LOCAL PLANNING PANEL – THE HILLS SHIRE COUNCIL

DETERMINATION OF THE LOCAL PLANNING PANEL ON 16 NOVEMBER 2022 – DETERMINATION MADE ELECTRONICALLY

ITEM 1: LOCAL PLANNING PANEL – PLANNING PROPOSAL – 21-23 VICTORIA AVENUE, CASTLE HILL (4/2021/)

ITEM-1 LOCAL PLANNING PANEL - PLANNING PROPOSAL – 21-23 VICTORIA AVENUE, CASTLE HILL (4/2021/PLP)**THEME:** Shaping Growth**MEETING DATE:** 16 November 2022

Figure 8

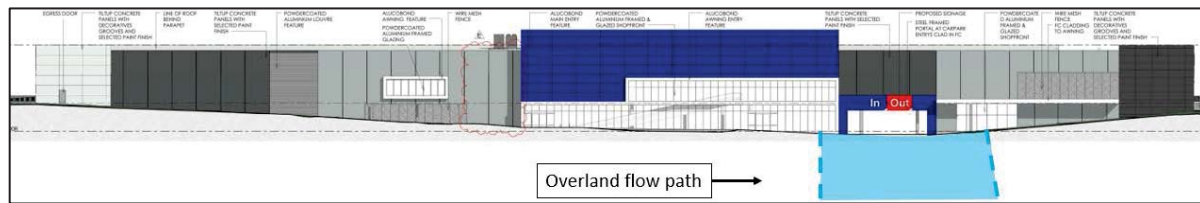
The Proponent has sought to justify the proposed development outcomes by elevating part of the building at the ground plane over the overland flow path, where water can pass through the site at a lower level. The Proponent indicates that this is an acceptable outcome as it is consistent with a previously approved Development Application (1/2014/JP) for the site (that has not been acted upon). A section of the approved DA is provided in the following figure.

While some of these conditions can be resolved at the Development Application stage, there are a number of conditions of the consent that identify issues that need to be resolved at the planning proposal stage in order for Council to have comfort that a future Development Application could be approved. Specifically, the provision of access to manage and maintain

Councils stormwater assets, the development imparting any loads greater than the pre-development loads upon the existing stormwater infrastructure or its excavation zones and the preparation of a satisfactory Flood Emergency Response Plan.

Figure 12
Floor Plans of Development Concept (Basement to Upper Ground)

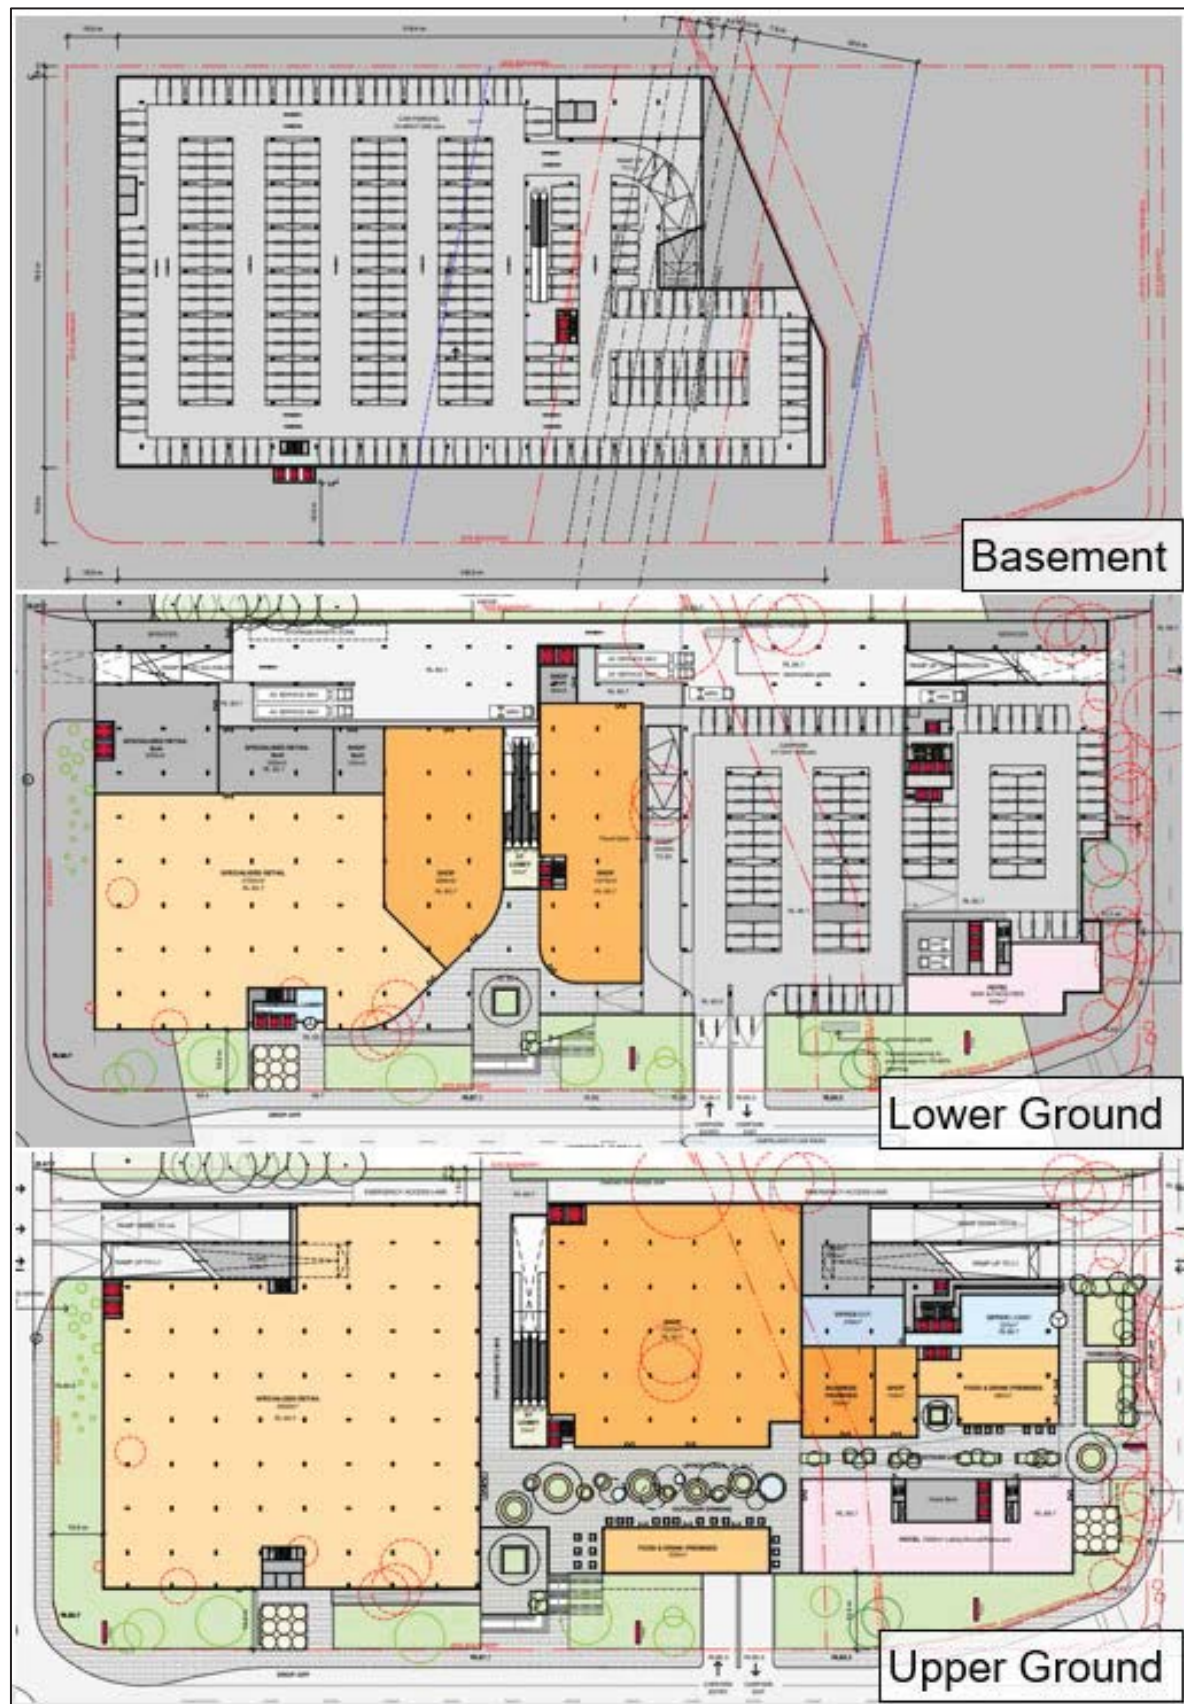
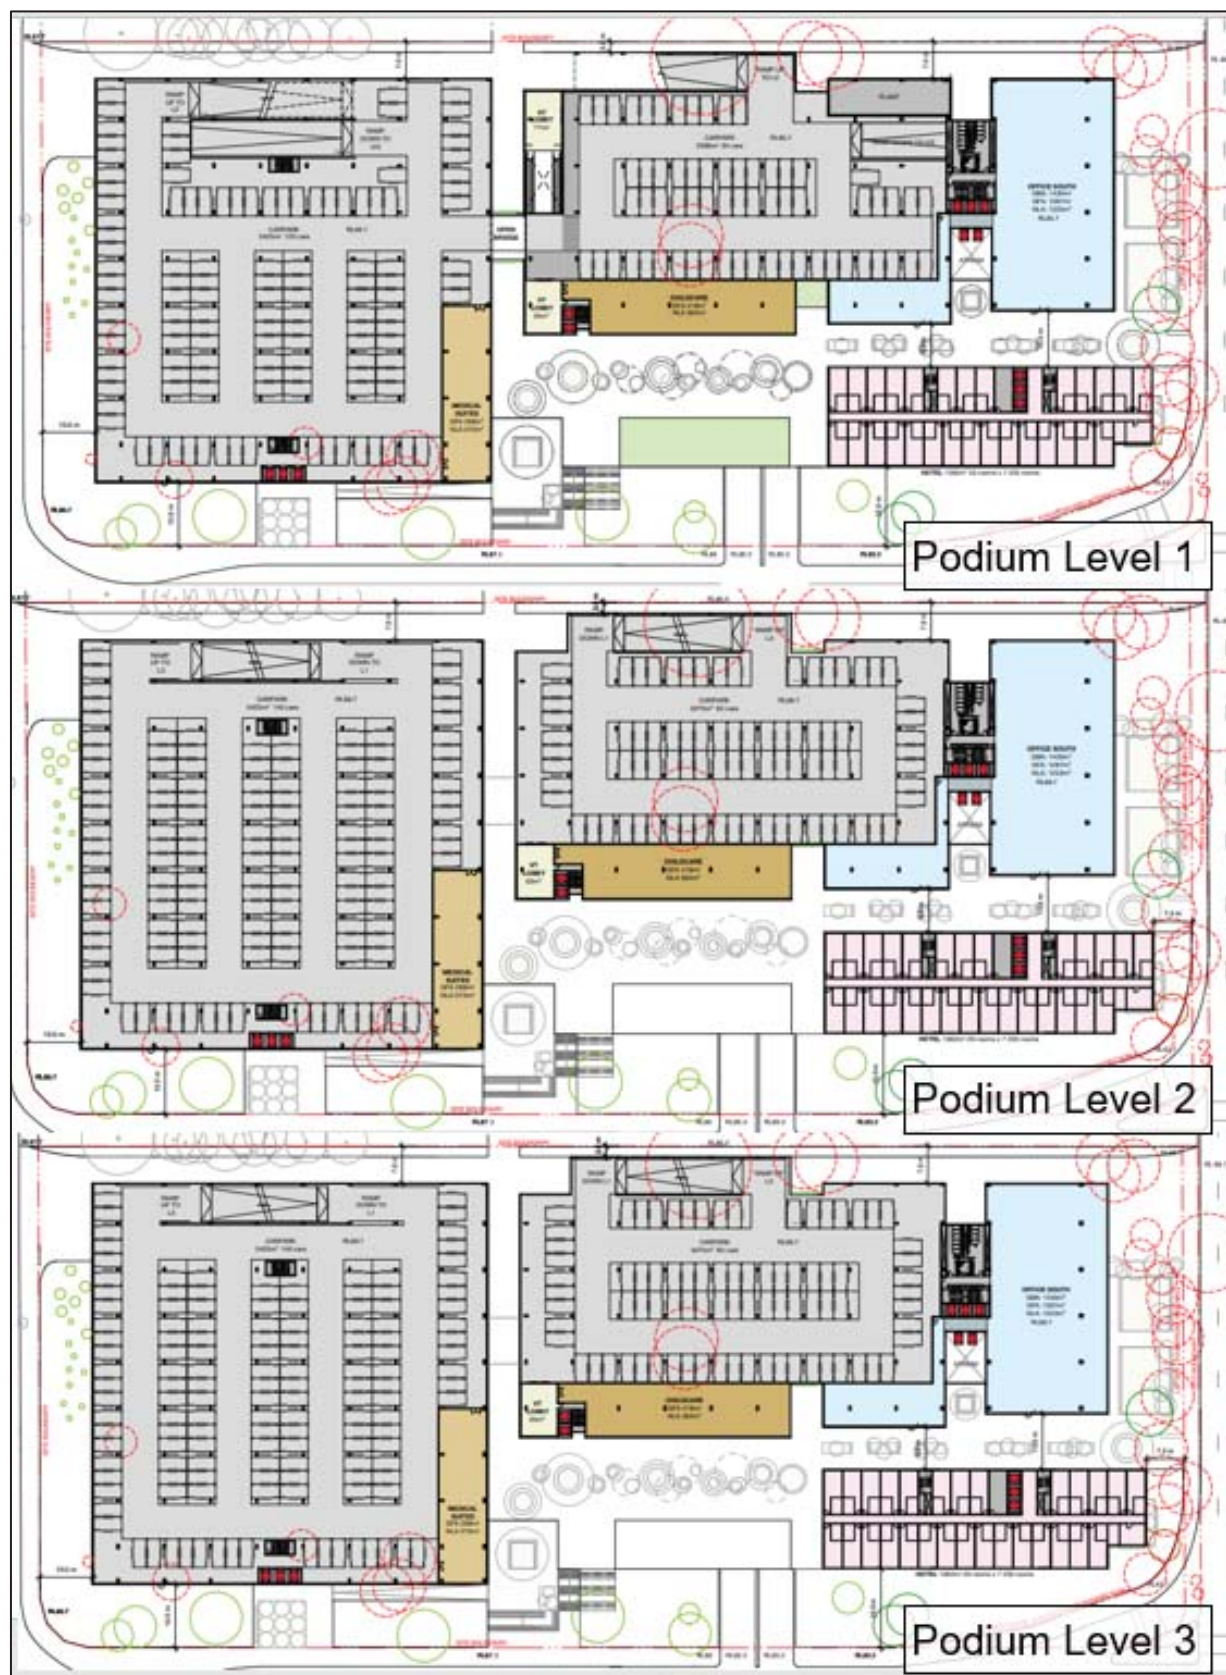
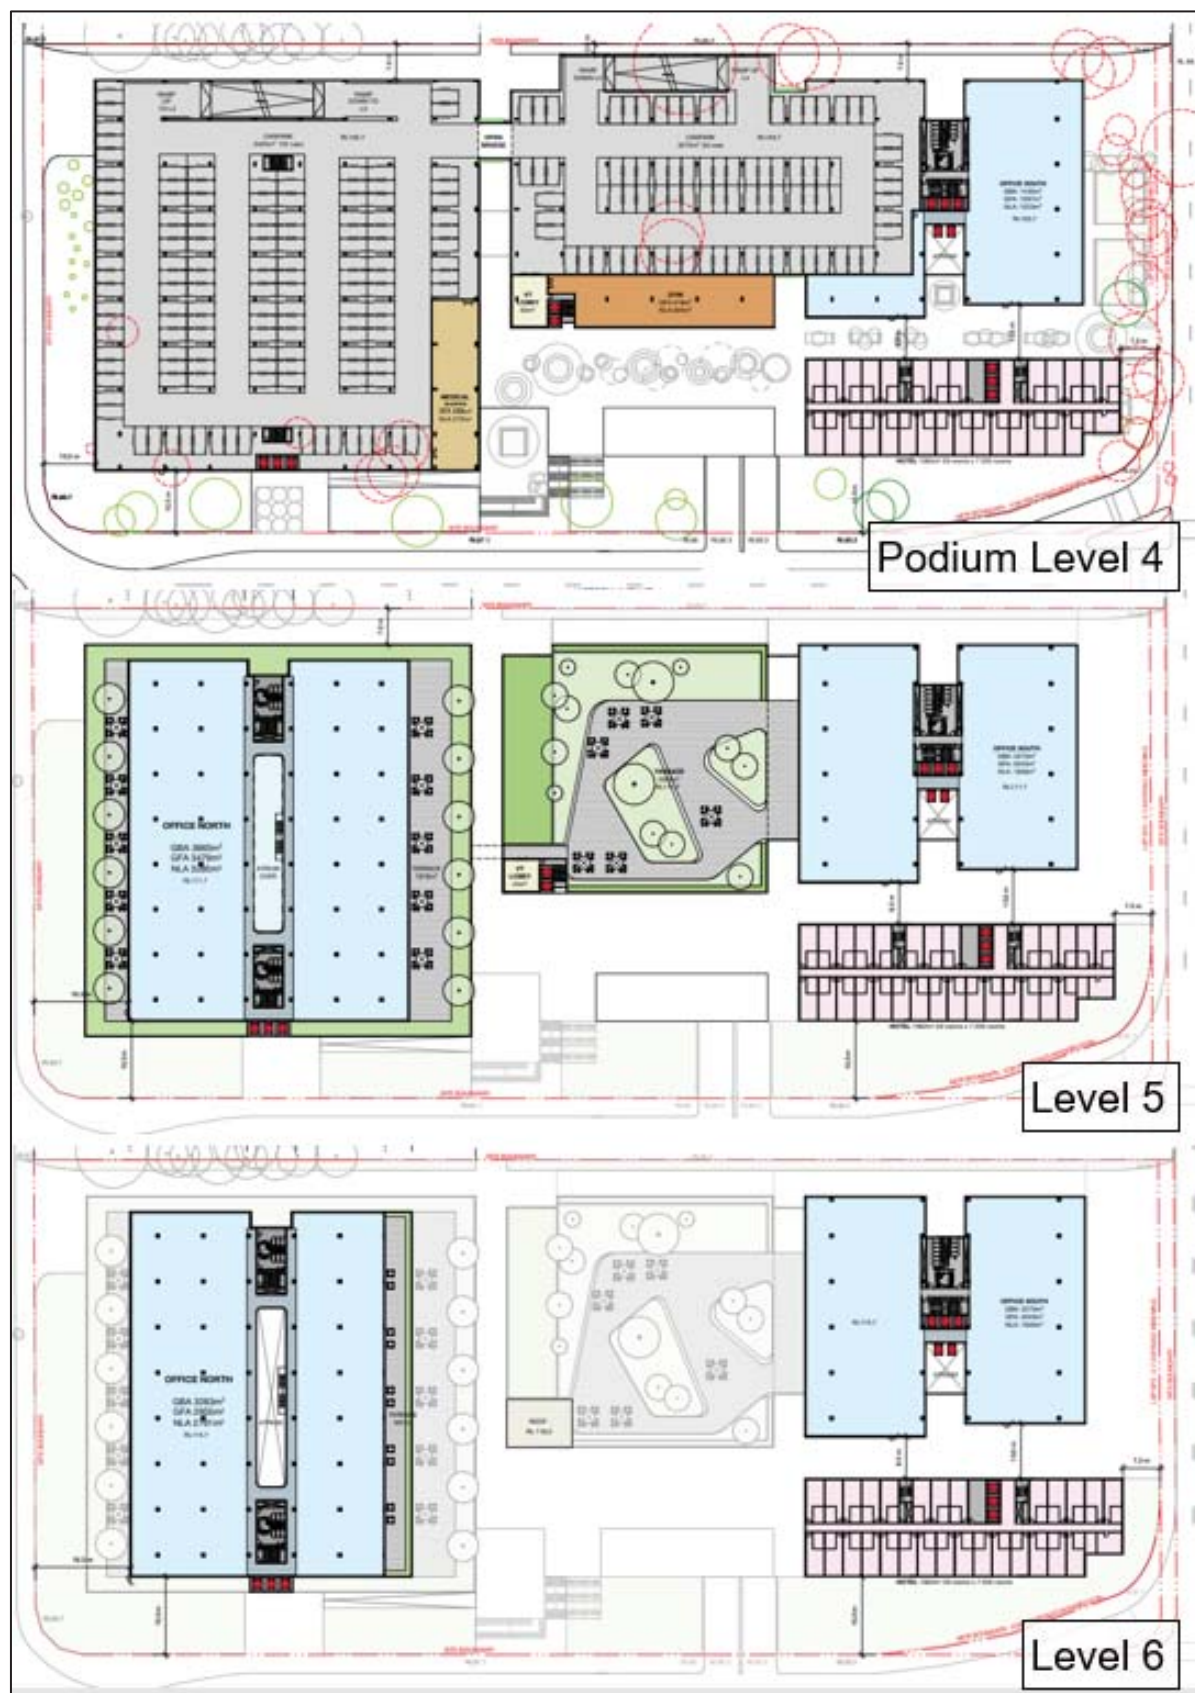
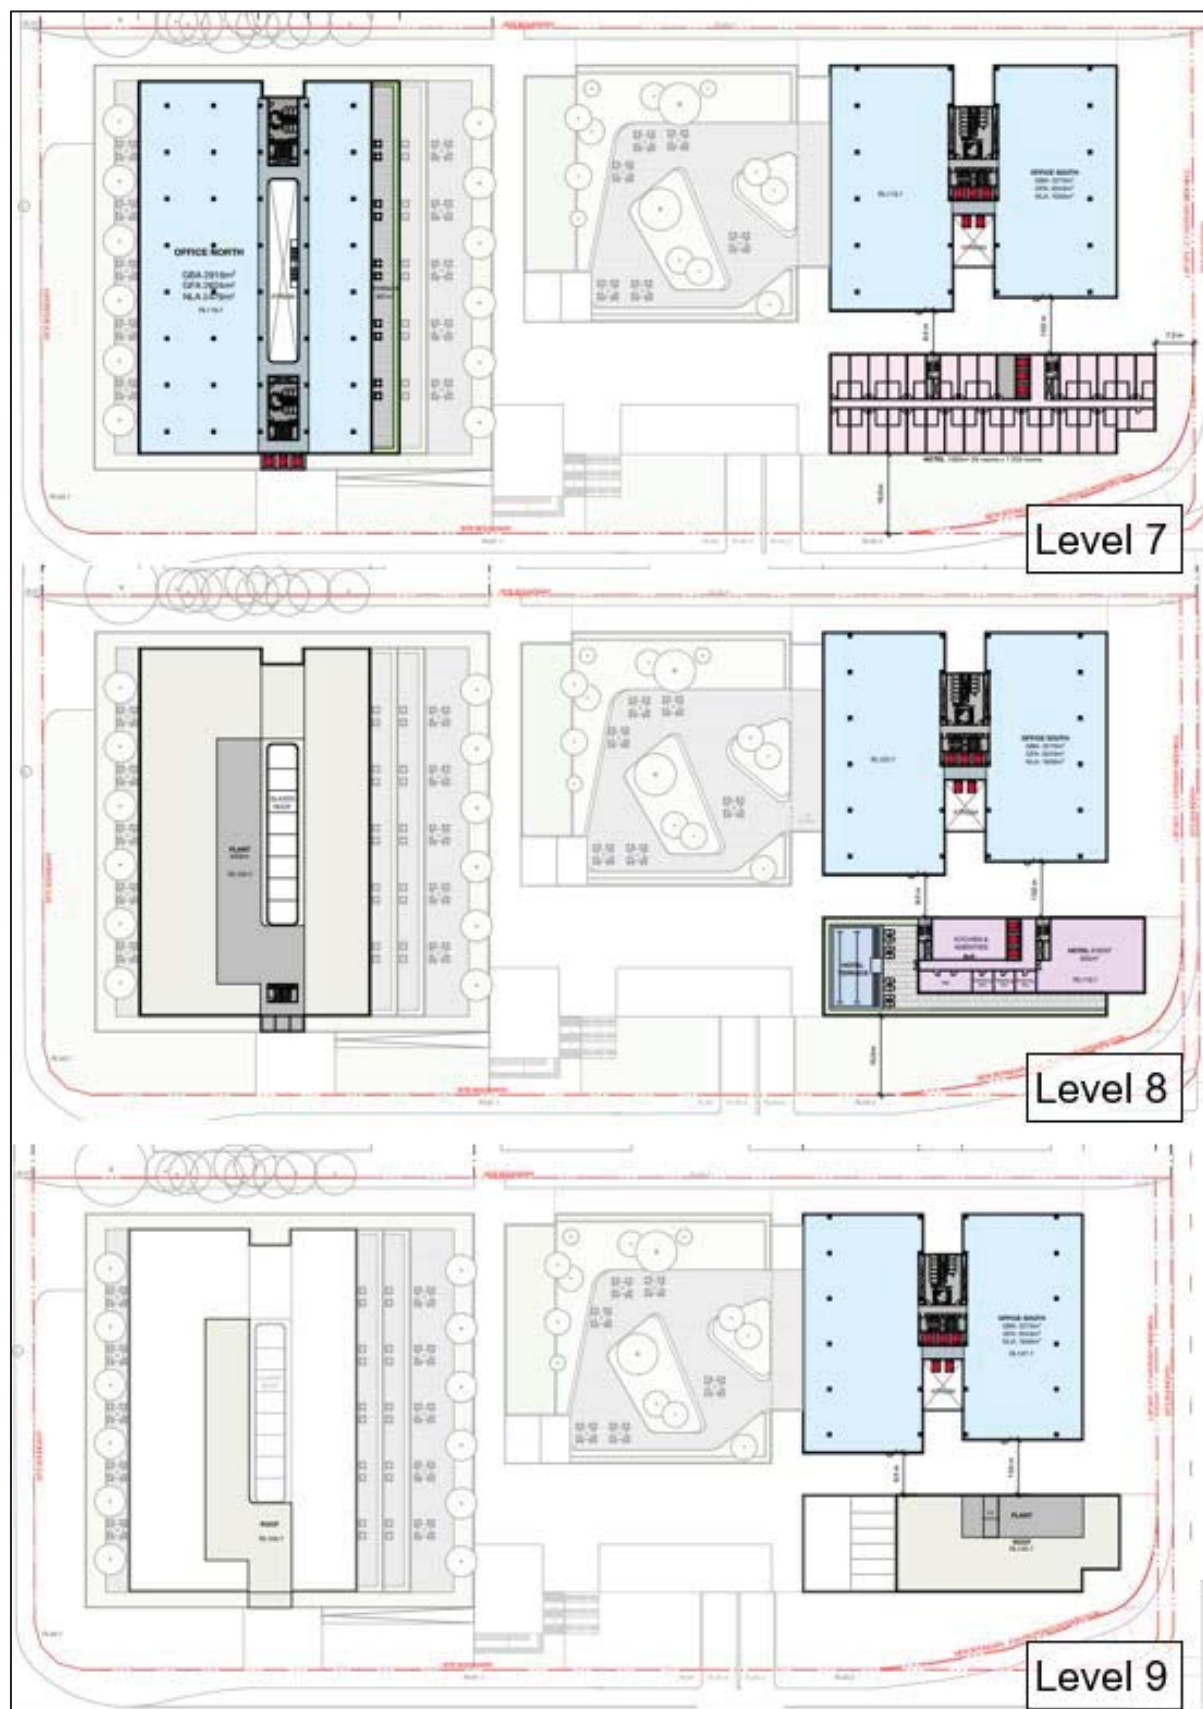
The following figures provide a level by level representation of the intended uses, which depicts the extent of building envelope that would need to be occupied by car parking if the proposed changes to the planning controls, as submitted by the Proponent, were to progress. As can be observed, this includes 4 storeys of large floorplates between the 3rd and 6th storey.

The floor plates associated with the proposed bulky goods retail uses (lower ground and upper ground) are very large, in the order of up to 5,000m², which is typical for bulky goods retail. The provision of these floor plate sizes to accommodate the continuation of retail outcomes on the site is supported. However, the extrusion of these floor plates for an additional 4-5 storeys, to accommodate car parking within the building envelope is problematic from a bulk and scale perspective.
